# Access Compliance Report

## Public Rights-of-Way

Intersection ID: 19143	Main Street: EDMONT_RD	Cross Street: PROVIDENCE_RD	Location: SW
ADA ID: B7DAB69382DD	Ramp Type: ParaDiag	Initial Pass/Fail: Fail	Overall Compliance: No
			Severity Score: 18.75

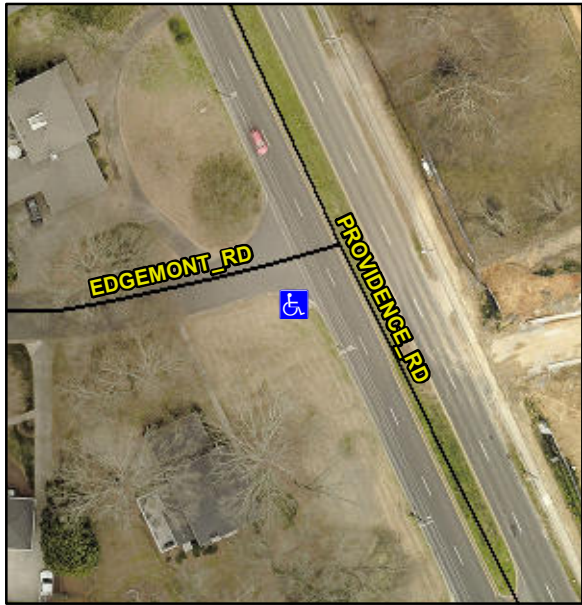
Codes/Mitigation Info/Possible Solution			Field Measurements/Component Compliance					
	Possible Solutions:		Compliance	Description	Data	Compliance	Description	Data
	<b>Remove &amp; Replace Curb Ramp With Two New Directional Ramps or Equivalent.</b>		N/A	Ramp Length LT (in)	59.0	N/A	Ramp Length RT (in)	60.0
			No	Ramp Width LT (in)	33.0	No	Ramp Width RT (in)	33.0
			Yes	Ramp Slope LT (%)	5.2	Yes	Ramp Slope RT (%)	7.4
			No	Ramp XSlope LT (%)	2.8	No	Ramp XSlope RT (%)	4.3
			N/A	Landing Length (in)	N/A	N/A	DWS Provided?	N/A
			N/A	Landing Width (in)	N/A	N/A	DWS Contrast?	N/A
			N/A	Landing Slope (%)	N/A	N/A	DWS Length (in)	N/A
			N/A	Landing X Slope (%)	N/A	N/A	DWS Full Width?	N/A
			N/A	Landing Curb? (Y/N)	N/A	N/A	DWS Offset (in)	N/A
Surveyor Notes:			N/A	Shared Landing?	N/A			
PROW/ADA:			N/A	Gutter Ponding?	N/A	N/A	Gutter Slope (%)	N/A
<b>R304.5.1, R304.5.3</b>			N/A	Gutter Lip Ht (in)	N/A	N/A	Gutter X Slope (%)	N/A
